PRODUCT UPDATE **INTRAAX® AAT Air Spring Pedestal**

LIT NO: P26016

DATE: October 2017

Fabricated & Welded Pedestal (Old)

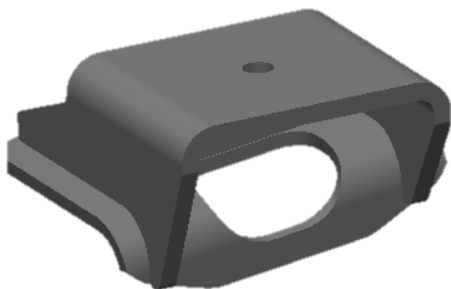
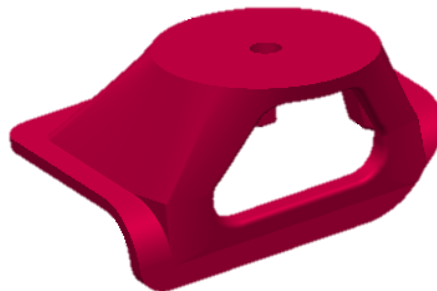
Hendrickson Trailer Commercial Vehicle Systems announces a change to bolt-on air spring pedestals on INTRAAX® AAT integrated air suspension systems with a 13.5-inch or 14-inch ride height.

Previously, the bolt-on pedestal was a fabricated and welded design. The new bolt-on air spring pedestal features a cast design, which helps reduce weight. Installation and hardware for the new cast pedestal remains unchanged.

All new shipments of INTRAAX AAT models with a 13.5-inch or 14-inch ride height will be equipped with the new cast pedestal design. The aftermarket bolt-on pedestal kit part number, S-32164-1, remains unchanged; however, the kit will be supplied with the new cast pedestals as shown in the illustration above.
